STATE OF HAWAII
DEPARTMENT OF TRANSPORTATION
HIGHWAYS DIVISION

ADDENDUM NO. 2
for
SLOPE IMPROVEMENTS FOR EROSION CONTROL
AT VARIOUS SITES ON OAHU, PHASE 8
PROJECT NO. HWY-O-01-18

*BOTTOM OF SLOPE
ANCHOR TRENCH DETAIL*

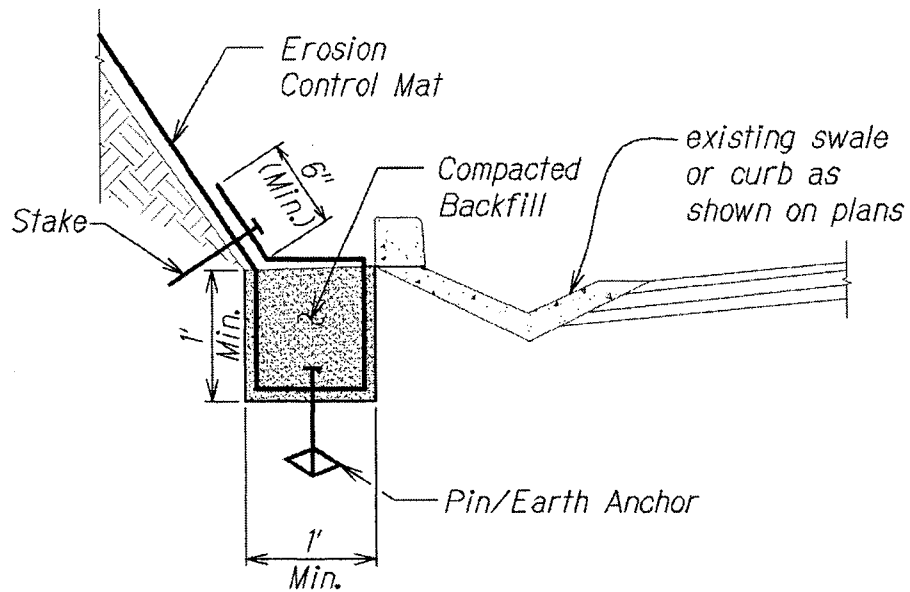
1. Add to Sheet EC-01 the "Bottom of Slope Anchor Trench Detail" shown in Attachment "A".
